Attachment 3 – HDC Memos

Draft Brookvale Comments

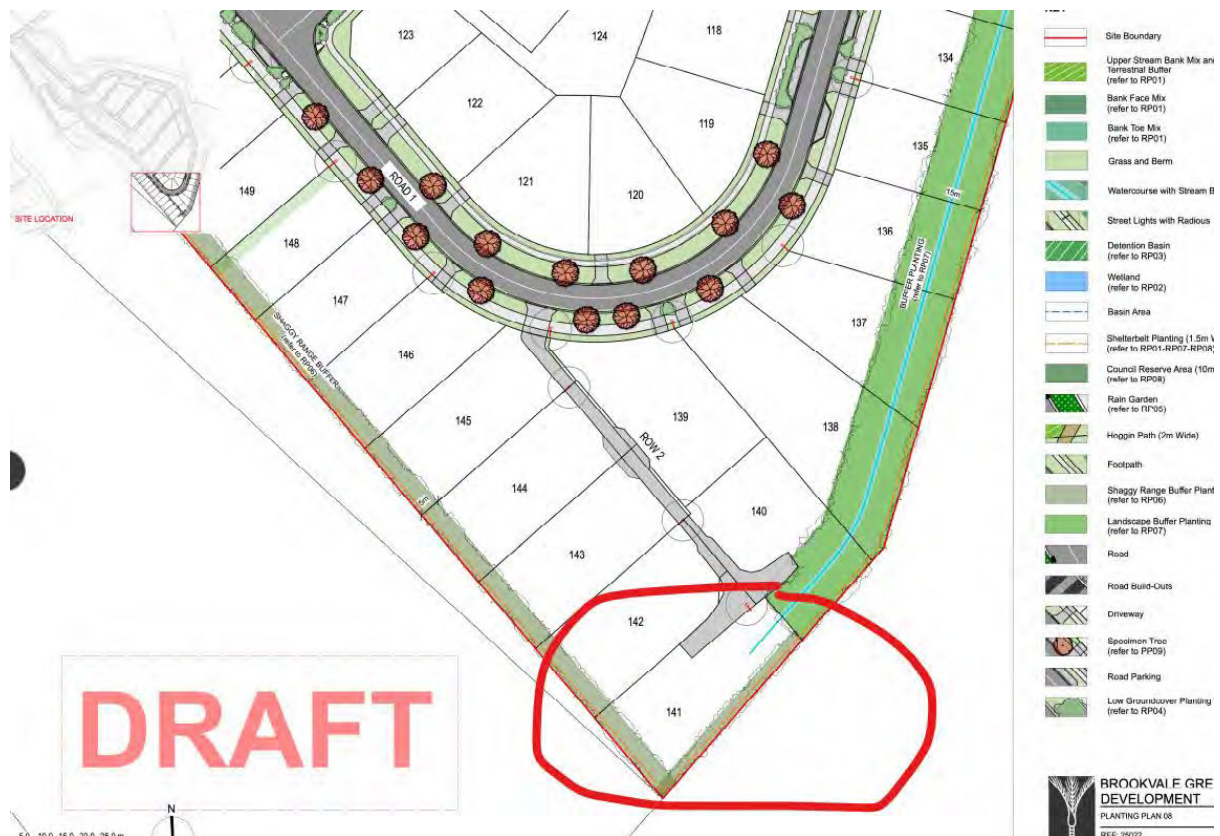
The report recommends shelterbelt planting along all rural interfaces, including planting relatively close to boundaries (with the report suggesting setbacks as low as 2 m) and achieving heights of approximately 3–4 m at maturity. However, the Hastings District Plan requires shelterbelt planting over 20 m in length to be set back at least 5 m from boundaries, with height controls linked to that setback. These provisions generally allow for maintenance of shelterbelts

within horticultural properties. It is noted that the applicant has not addressed the ongoing maintenance of these shelterbelts, particularly the need to provide space to allow appropriate machinery to access the trees. It is requested that the applicant provide details of ongoing maintenance to ensure the proposed mitigation approach is the most appropriate for this development.

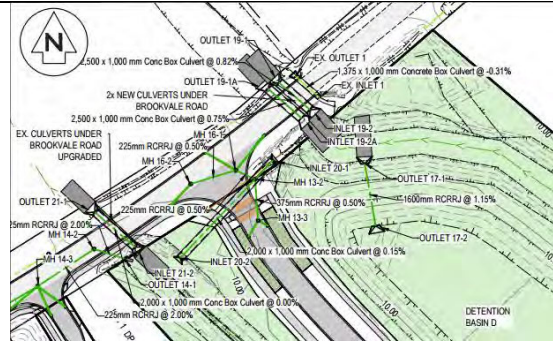
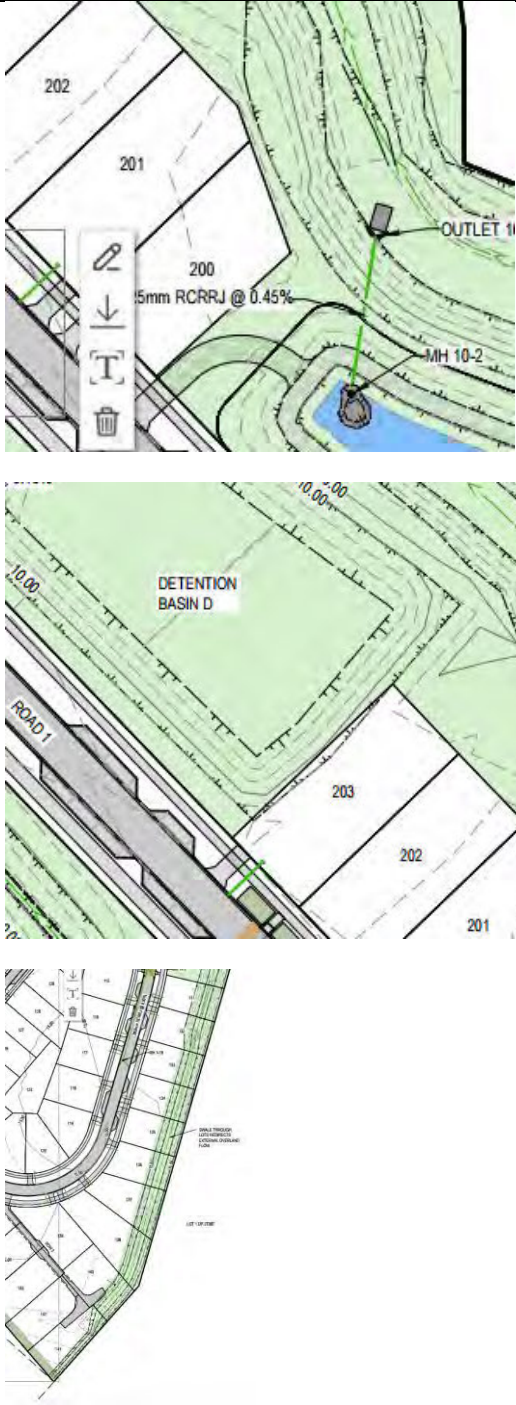
S4	Rain gardens RG3/4/5 too narrow to fit 1:3 batters;
S5	Some new and some increased culverts under Brookvale Rd. Potential worsening of downstream flooding and effects not addressed. Upgraded/new culverts may create perception of increased discharge to downstream private land.

S6	Limited space behind Lots 200–201 for watercourse maintenance. Basin D has no setback from Lot 203. Watercourse 2 (Lots 181–188) has constrained access. In general, HDC would require a 6m setback from the drains and watercourses. This would be applicable in this case.	 The top drawing is a plan view of a watercourse system. It shows lots 200, 201, and 202. A watercourse is shown with a slope of 5mm RCRRJ @ 0.45%. A manhole labeled 'MH 10-2' is shown. The middle drawing is a plan view of 'DETENTION BASIN D' located between 'ROAD 1' and lots 201, 202, and 203. The bottom drawing is a plan view of a watercourse with a 'LOT 181-188' and a 'LOT 189-190'.
-----------	---	--

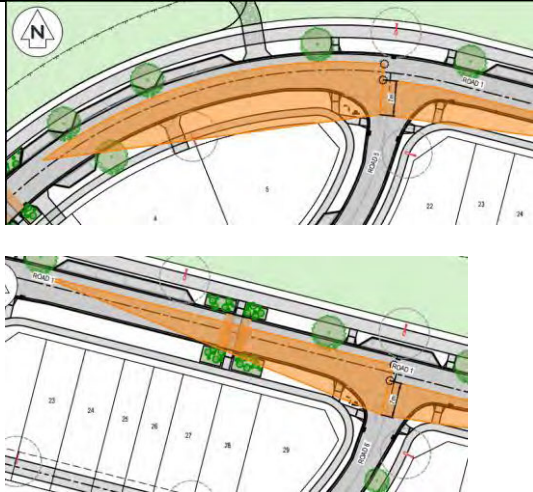
S7	Can the applicant confirm the side slopes for the proposed watercourse, swales, and drains, and assess the maintenance of these elements?	
S8	Rear-lot swale (Lots 131–141) occupies >1/3 of each lot; privately maintained -High long-term failure risk.	
S9	Unclear to what performance the watercourses are modelled; in short grass, some do not have access to maintain design Manning performance. Manning's roughness may increase due to vegetation; only one side is maintainable. Stress test on higher Manning and peer review flood report	
S10	Sw outlets, as bubble-up chambers, indicate constant surcharge operation for the stormwater pipes. This is a bit unusual and will need to be confirmed	
S11	Public stormwater over private properties (169-177). The general approach is that public SW over private property is not preferred. Maybe this can be redesigned for individual private easement over lower properties

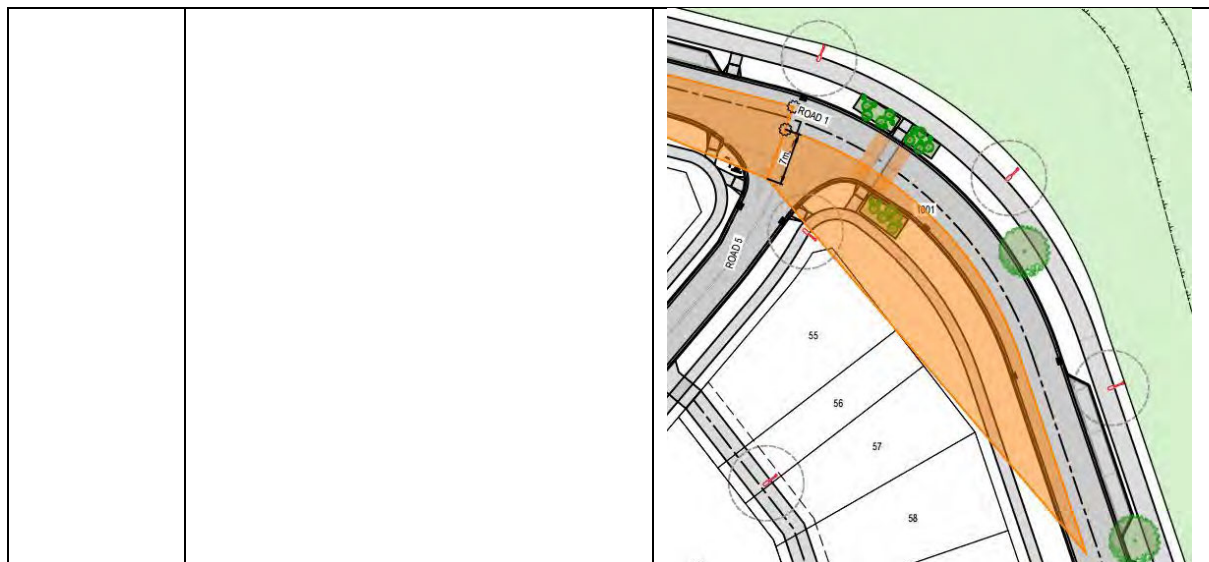
Roading	
R1	Road long-section shows 0.27% grade (below 0.4% minimum).
R2	1:3 berm batters shown on C330-5/6 are too steep for standard mowing; long-reach mowing may not be feasible.
R3	Lots 177–180 have dual-frontage exposure; Lot 180 exposed on three sides.
R4	Visibility Visibility splays at Road 5 are obstructed by the Lot 5 fence and vegetation near Lots 6. Turning Lots 6 - view through the vegetation – confirm the size of the plans Road 5 – view through the Lot 55 boundary

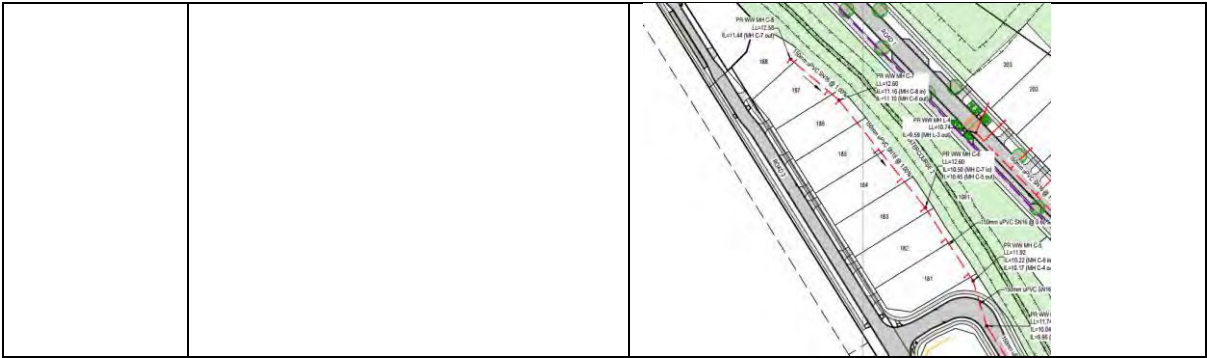
Wastewater		
W1	Opportunity to extend the gravity main to reduce the rising main length along the Brookvale Road. Connection from the rising main to the gravity main should be on an individual receiving chamber to reduce disturbance of the existing flow.	
W2	Some pipes at minimum grade (0.48%). Self cleaning velocities to be provided.	
W3	Lots 181 to 188 would ideally have public connection on the road rather than at the back of the site, where it is hard to access, and any future inspection and maintenance is challenging. similar comments for the Lots 169-177

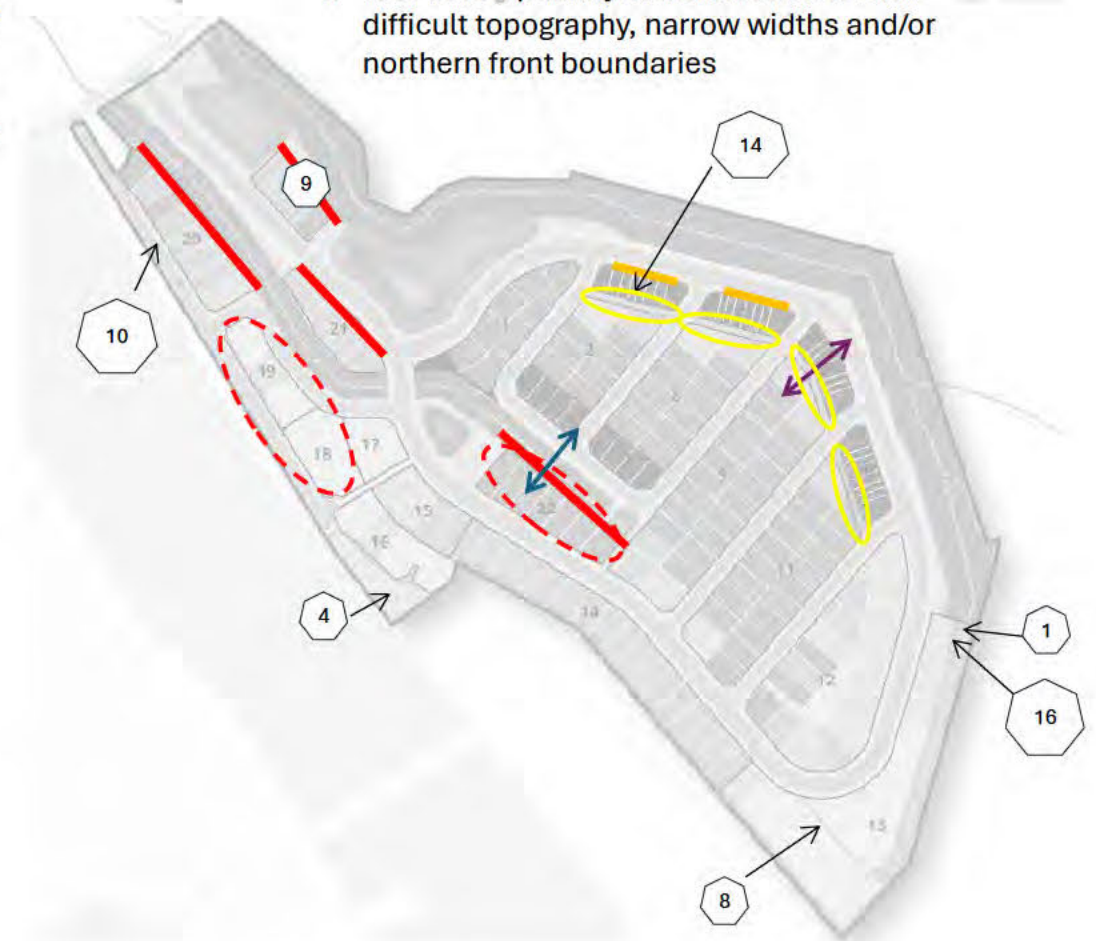
14. Will there be sufficient separation distance between rows of terrace houses and detached houses on neighbouring lots? (Best practice is 15m between walls) e.g. lots 87 and 93.
15. Have you tested lot designs for a-typical shape lots and those with multiple frontages? E.g. lot 5 below.
